## CITY OF WASHINGTON, ILLINOIS

### Public Works Committee Agenda Communication

**Agenda Item:** Construction Standards Update

# **CONSTRUCTION STANDARDS**

## CUL-DE-SAC TYPICAL PLAN

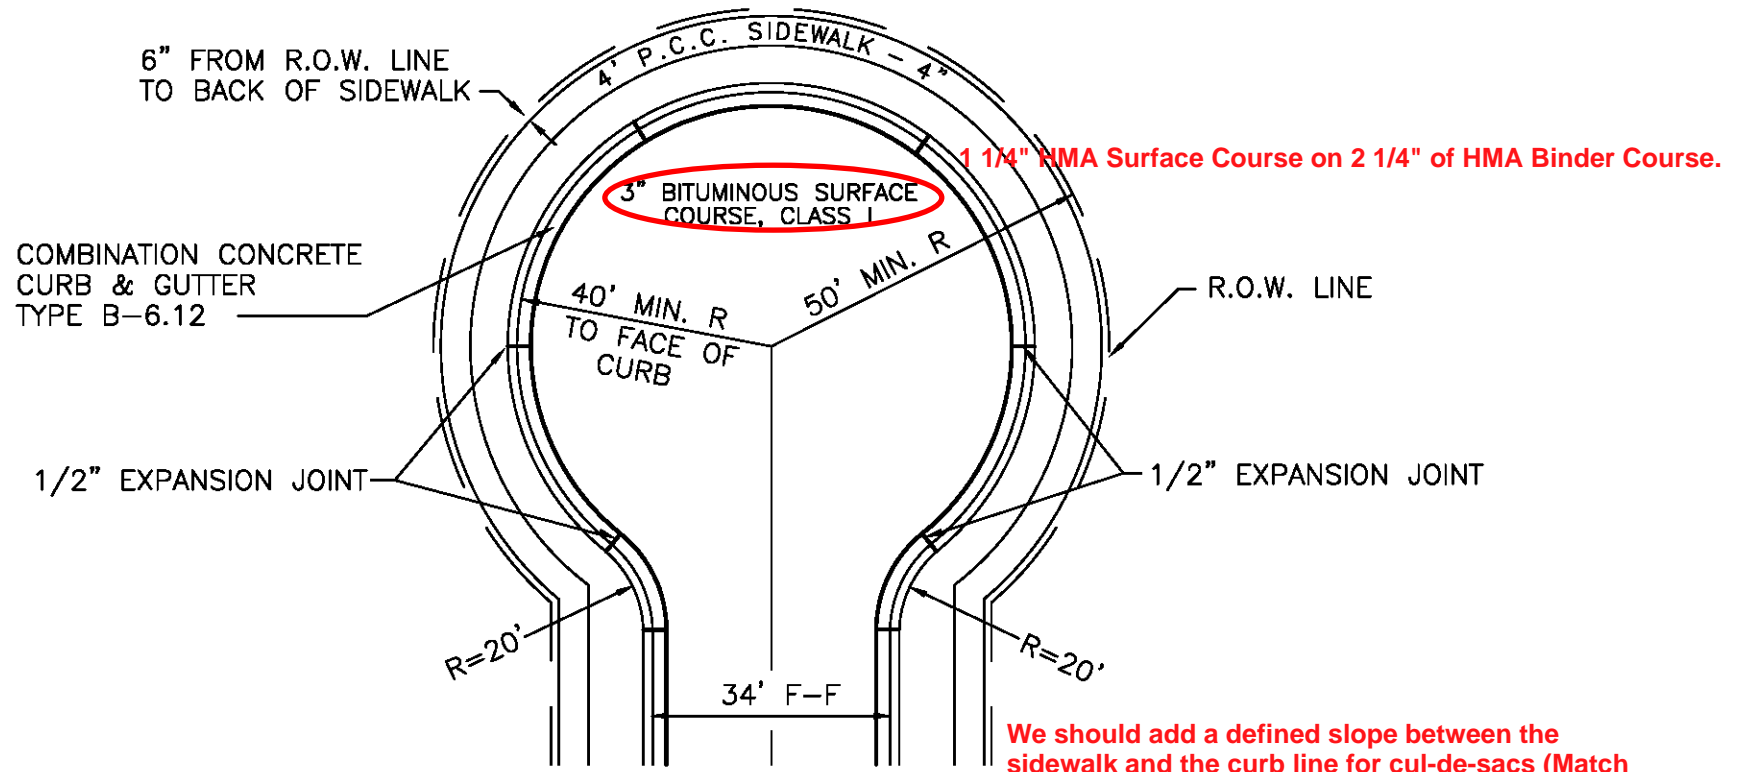
We should add a defined slope between the sidewalk and the curb line for cul-de-sacs (Match Residential XS)

## COMBINATION CONCRETE CURB AND GUTTER

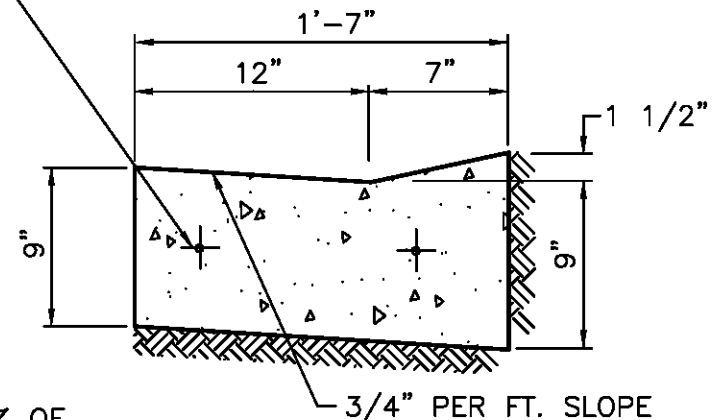
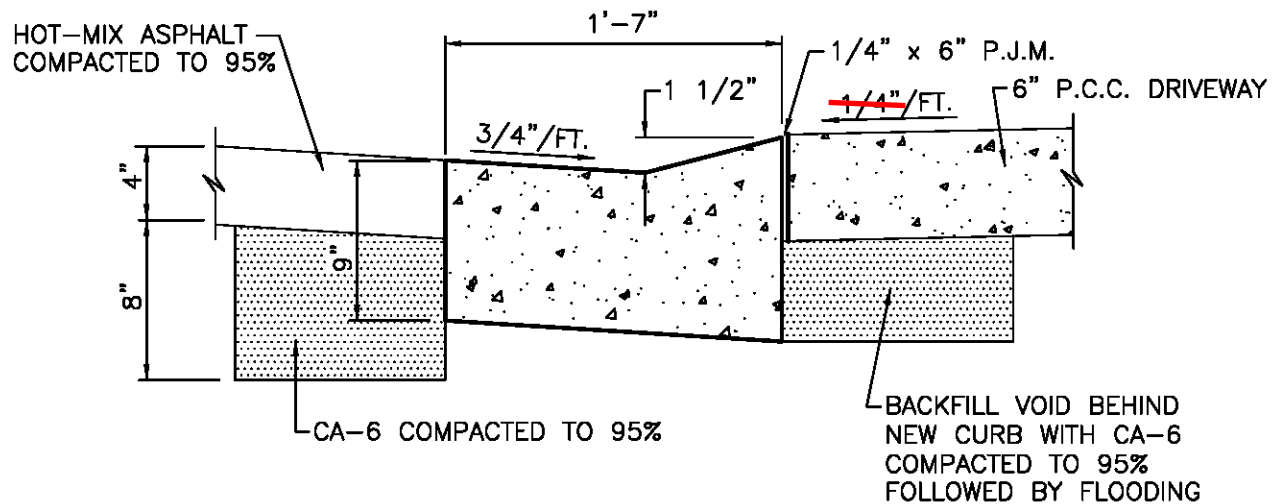
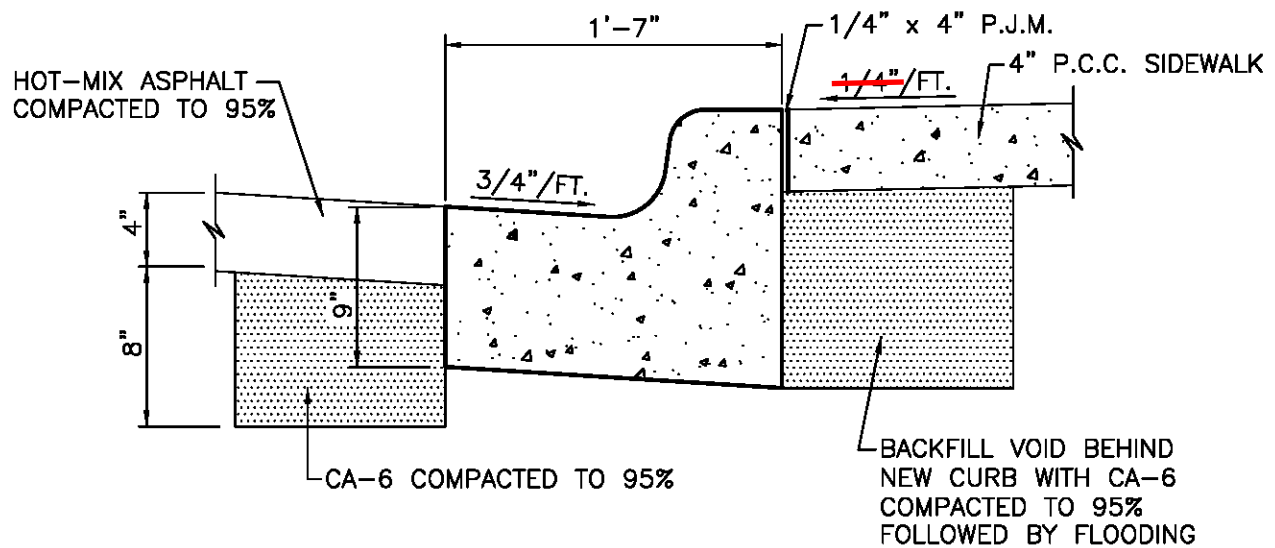
Differing the curb shape from IDOT's requires contractor's to create a new mold for their curb machines. Most of the local firms already have one made if they have done work in either Washington or Morton.

IDOT's Standard Curb is 1" Radius

IDOT's standard Curb has no radius

**COMBINATION CONCRETE CURB AND GUTTER REPLACEMENT  
WITH CURBLINE SIDEWALK**

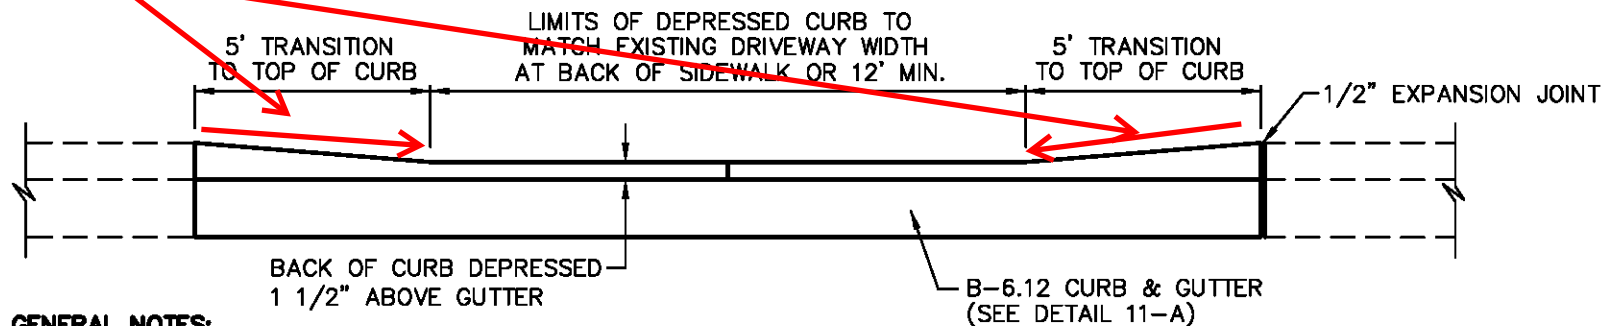
**NOTE: MAINTAIN ~~2%~~ CROSS SLOPE (~~1/4"~~ PER FOOT) THROUGH DRIVEWAY & TRANSITIONS.**

**Slope < 8.33% Unless Approved By the Engineer**
